CITY AND COUNTY OF SAN FRANCISCO
DEPARTMENT OF CITY PLANNING

FINAL
ENVIRONMENTAL IMPACT REPORT

1171 SANSOME STREET

PUBLICATION DATE: JUNE 10, 1983

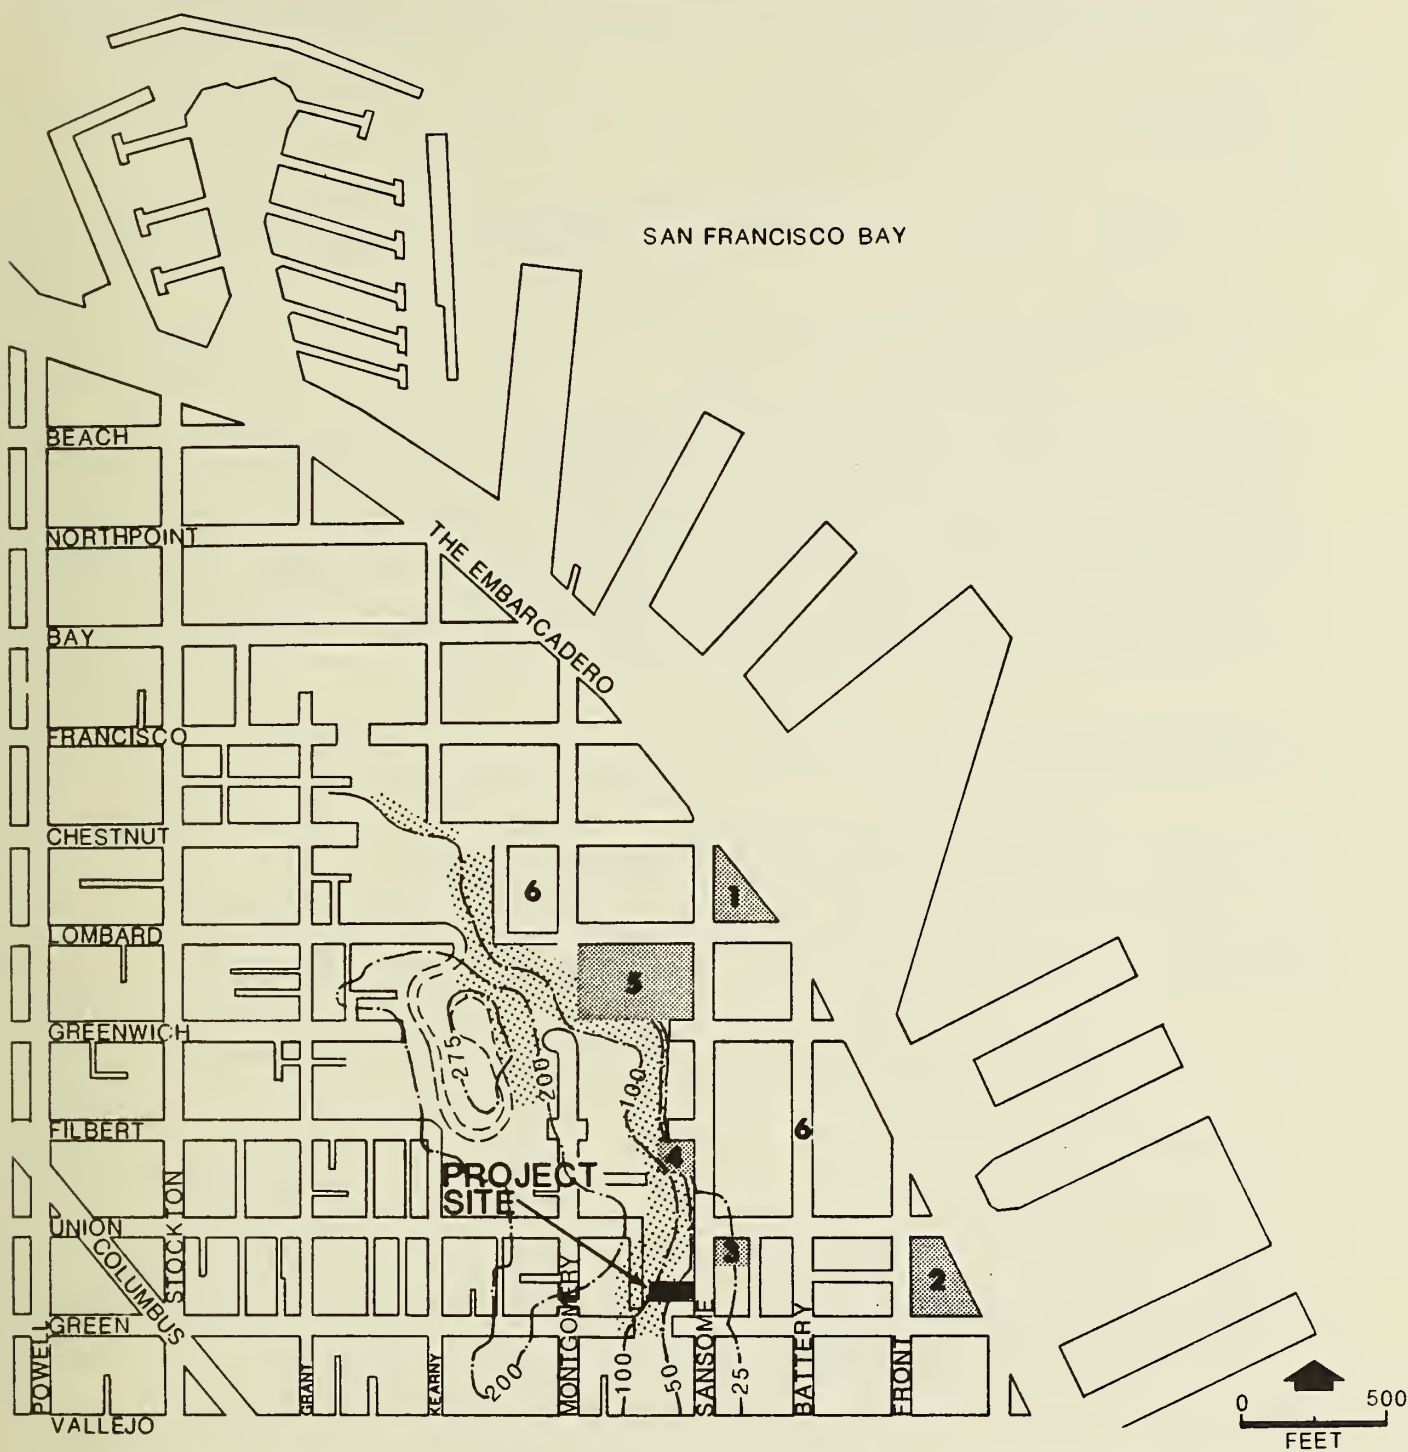
"The shadow diagrams in the initial study covered December, but I think because -- although it isn't going to be a used rear yard, as best I can tell, I think we ought to take
